**Re: Maplegate South Solar Array
160 Maple Street
Site Plan Peer Review Response**

BETA REVIEW LETTER DATED 9/21/2023

DATE: February 21, 2024
TO: Franklin Planning Board
FROM: Department of Planning and Community Development
RE: Maplegate Solar South
Site Plan

SHEET TITLE: **PROPOSED CONDITIONS DRAINAGE AREA MAP (C)**
 SHEET NUMBER: **PRDAM-C**
 ORG. DATE - 02/16/2024

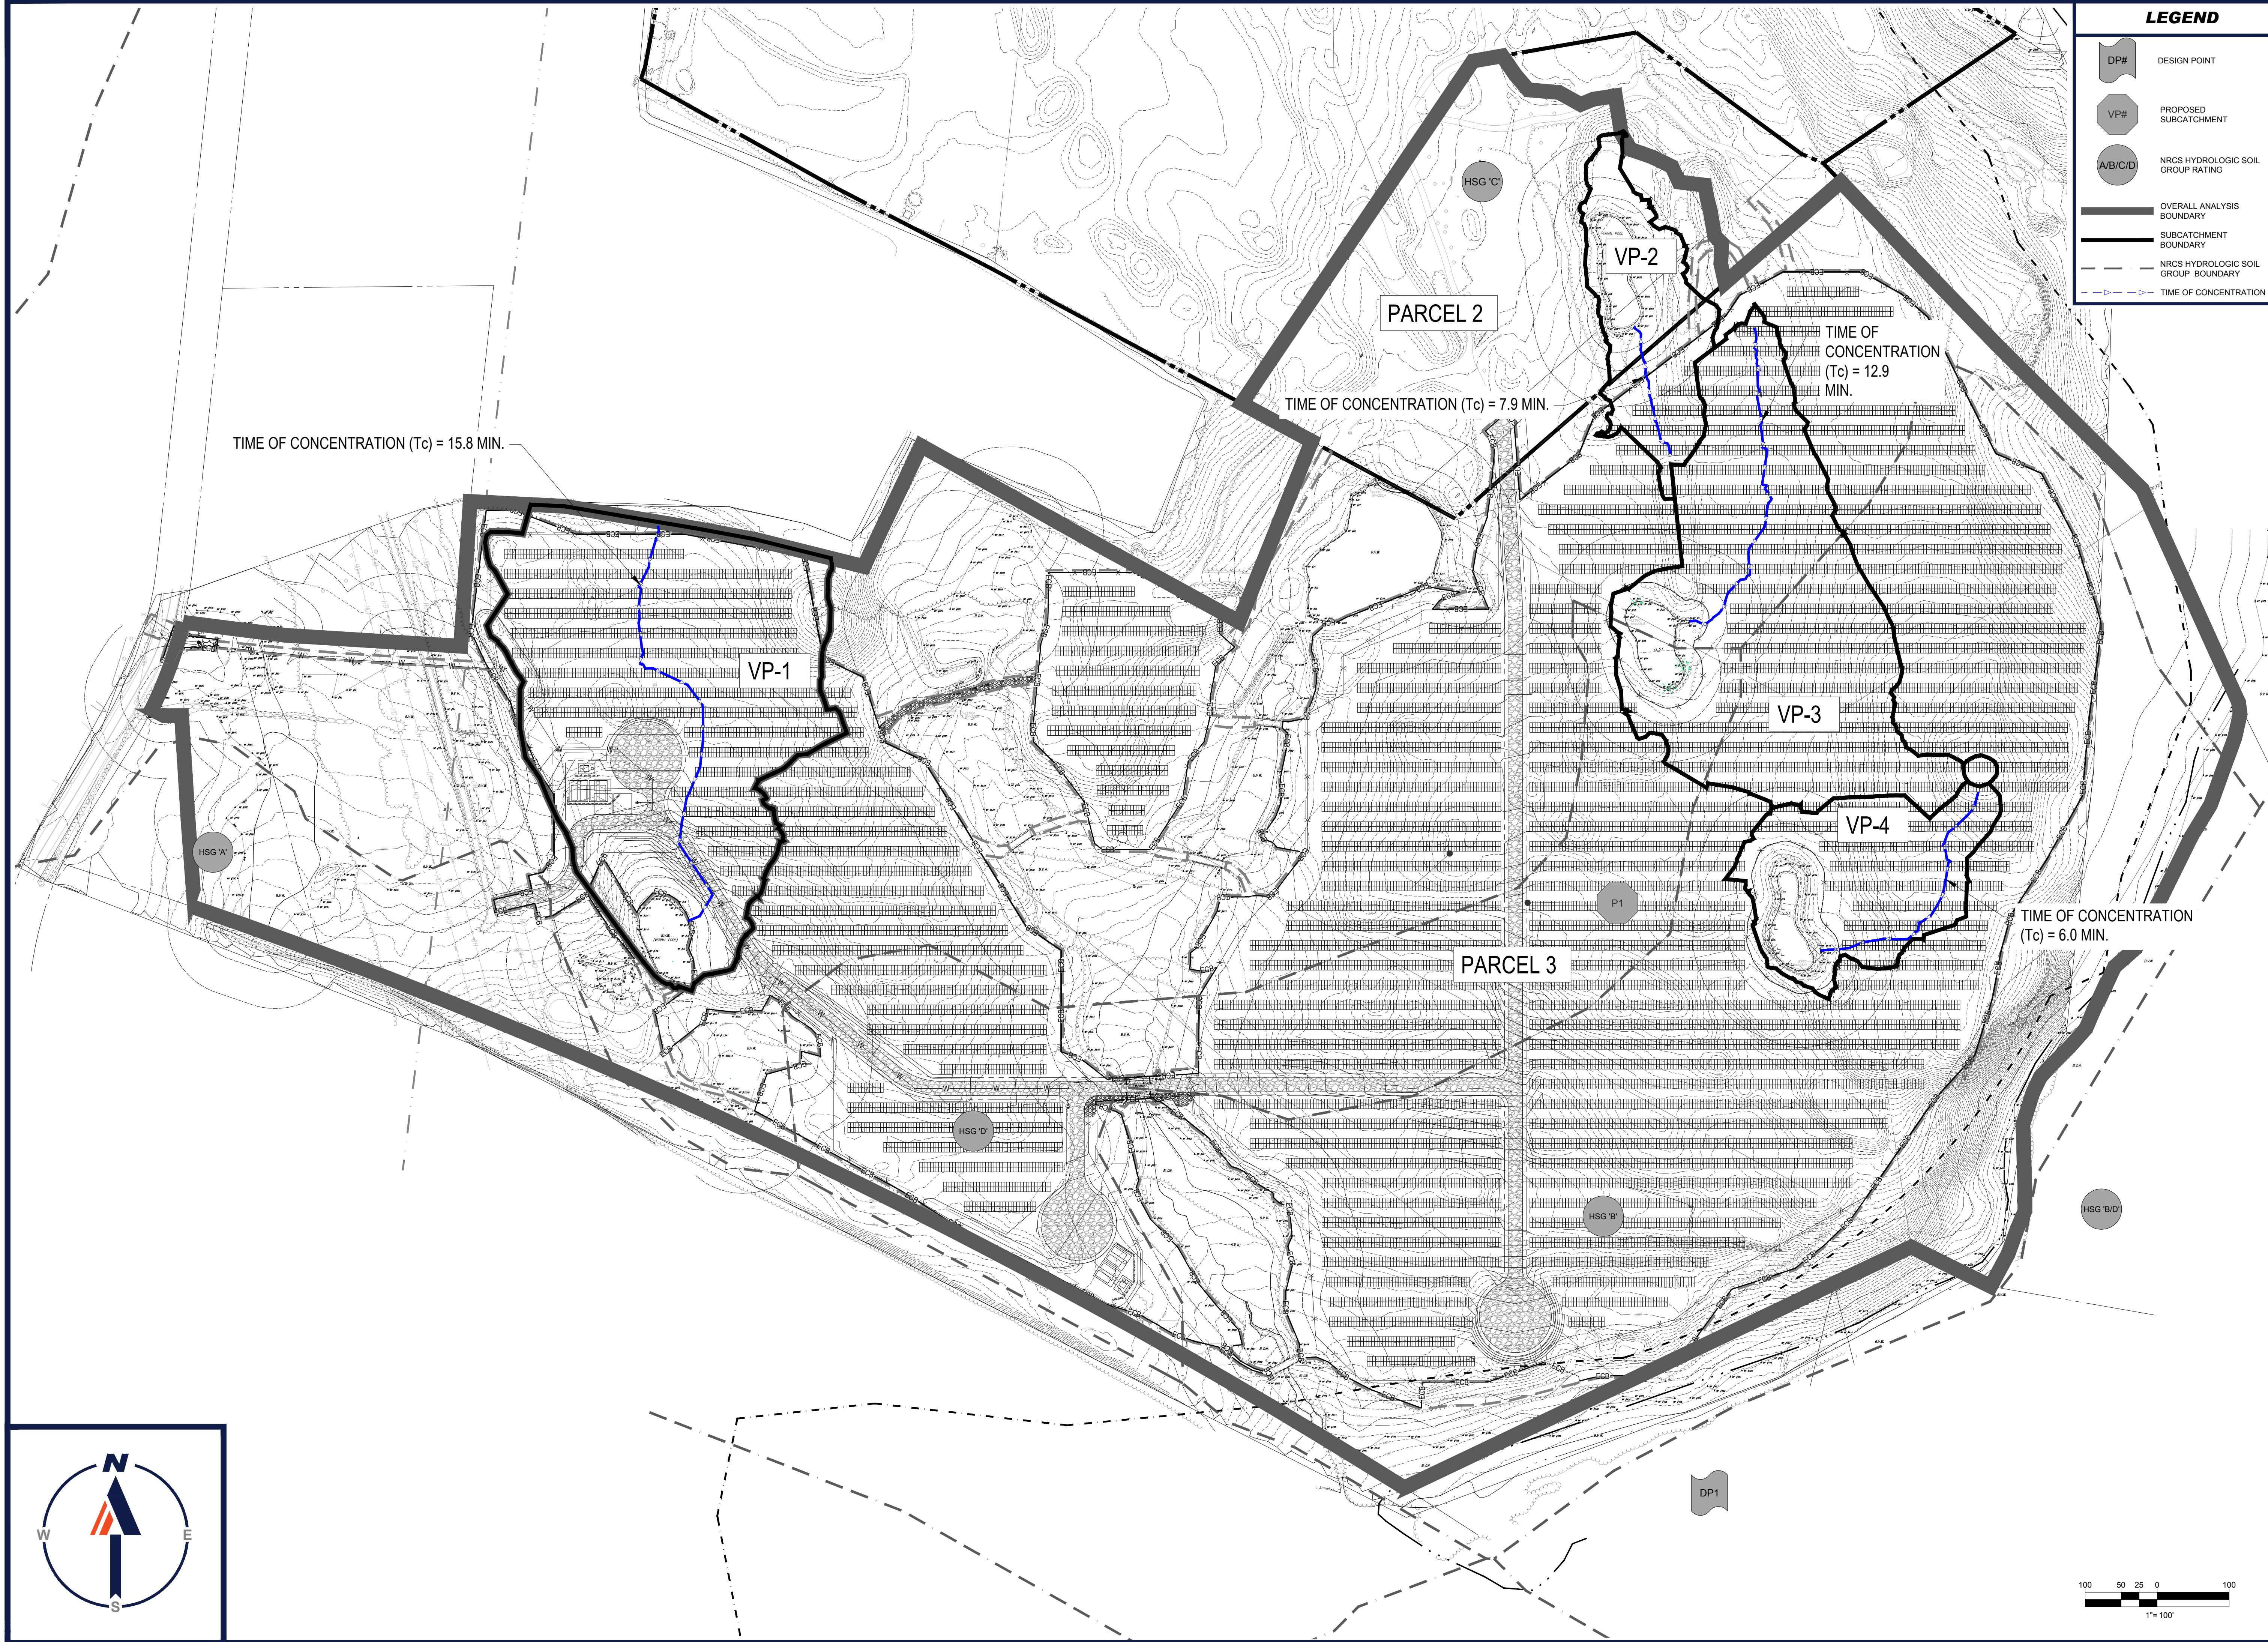
Comment SW3. Depict existing treeline to remain and proposed limits of clearing on the post-development watershed plan.

Comment SW4. Revise the Tc calculations in both existing and proposed conditions. The flow path shown on the watershed plans is incorrect and should not be limited to the intermittent stream alone.

Comment SW6.

The flow to the vernal pools should each be analyzed separately for both existing and proposed conditions.

Response: Acknowledged. The existing treeline to remain and proposed limit of clearing have been added to the revised post-development watershed plan.

Response: The time of concentration (Tc) as calculated in the existing and proposed conditions is not limited to the intermittent stream and has been determined to be the longest path of flow in the watershed. The flow path begins at the northern edge of a bordering vegetated wetland (BVW) with 50' of sheet flow and continues for approximately 630' of shallow concentrated flow through the BVW to the south. The flow path then continues for approximately 576' of shallow concentrated flow through an intermittent stream, which beings downstream of the existing culvert crossing (widened gravel road/culvert crossing in the proposed condition).

Response:

A HydroCAD analysis has been completed for each of the four (4) existing vernal pools (VP1-4) to determine the pre- and post-development conditions for the 2-, 10-, 25- and 100-year storm events. Refer to the HydroCAD reports included with this letter as well as Tables 3 and 4 below for a summary of pre- and post-development peak rates and volumes.

There are no changes in flow and volume characteristics to VP2. Both VP3 and VP4 experience a slight decrease in runoff rates and volumes in all storm events in the post-development condition, which is largely due to the replacement of gravel/paved cart paths with natural vegetated materials. VP1 experiences an increase in runoff rates and volumes in the post-development condition. LEC Environmental Consultants, Inc. is in support of the introduction of more water to VP1 given that the resource area is a standing water body with considerable vernal pool activity that is benefitting from a longer permanent pool duration.
